**U.S. NUCLEAR REGULATORY COMMISSION  
Office of Nuclear Material Safety and Safeguards  
Spent Fuel Project Office**

**INSPECTION REPORT**

Inspection Report: 72-1007/98-202

Certificate Holder: Sierra Nuclear Corporation  
One Victor Square  
Scotts Valley, CA 95066

Figure 1. Configuration of the MSB in the MTC and the TOFD scanning device

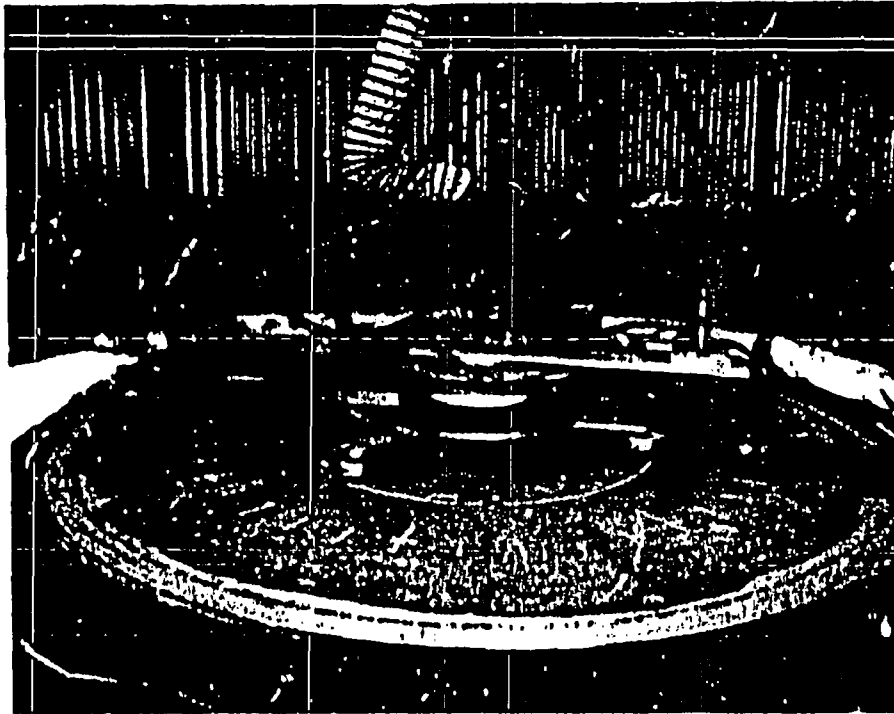
The MSB mockup was placed in a full-diameter, partial-height MSB transfer cask (MTC) to simulate the configuration for the loading process. Figure 1, in the accompanying attachment, shows the configuration of the MSB in the MTC and the TOFD scanning device. The team did not identify any significant differences between the mockup and the design of an actual MSB/MTC that would affect UT examination in the field.
